RENESAS TECHNICAL NEWS

No.ASSP-13-0309

M66291 IN-Direction DMA Transfer Limitations

USB ASSP M66291GP/M66291HP

Figure 1. Occurring Conditions

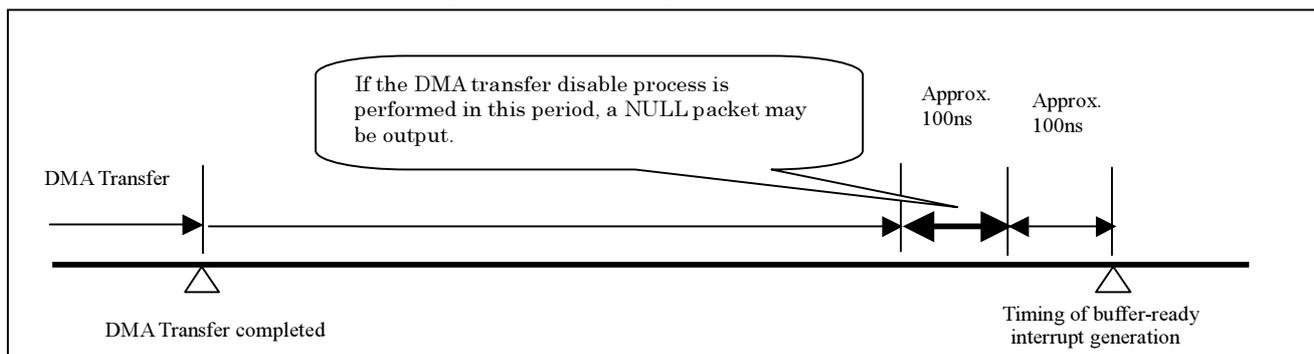
In a system that uses D0_FIFO or D1_FIFO (Dn_FIFO hereon) for DMA transfers to an endpoint set to the IN-direction (IN-endpoint), if the DMA disable process (write DMAEN = "0") is executed after DMA transfer is complete, a zero-length (Null) packet may be output in response to the IN Token in the endpoint on the USB bus.

The phenomenon described above may occur when all of the following conditions are present (see Diagram 1):

Condition 1: The endpoint designated to the Dn_FIFO is set to the IN direction

Condition 2: In the DMA transfer under Condition 1, the DMA transfer disable process (write DMAEN = "0") is executed after transfer completion.

Condition 3: The DMA transfer disable process (Condition 2) is performed immediately before (approx. -200ns to -100ns) the timing of the endpoint buffer-ready interrupt occurs.

*When this phenomenon occurs, the buffer-ready interrupt will not actually occur.

*This phenomenon does not occur when the DMA transfer disable process is executed after the buffer-ready interrupt is generated.

- (1) After transfer is complete, perform the DMA transfer disable process after the buffer-ready interrupt of the endpoint has been generated.
- (2) Disable DMA transfer (DMAEN = "0") using the following 2 processes in the order indicated.
 - 1). Write the following settings to the Dn_FIFO Select Register
DMA transfer enable (DMAEN = "1") and designated endpoint clear (DMA_EP = "0000")
 - 2). Write the following settings to the Dn_FIFO Select Register
DMA transfer disable (DMAEN = "0") and designated endpoint set (DMA_EP = "0000").
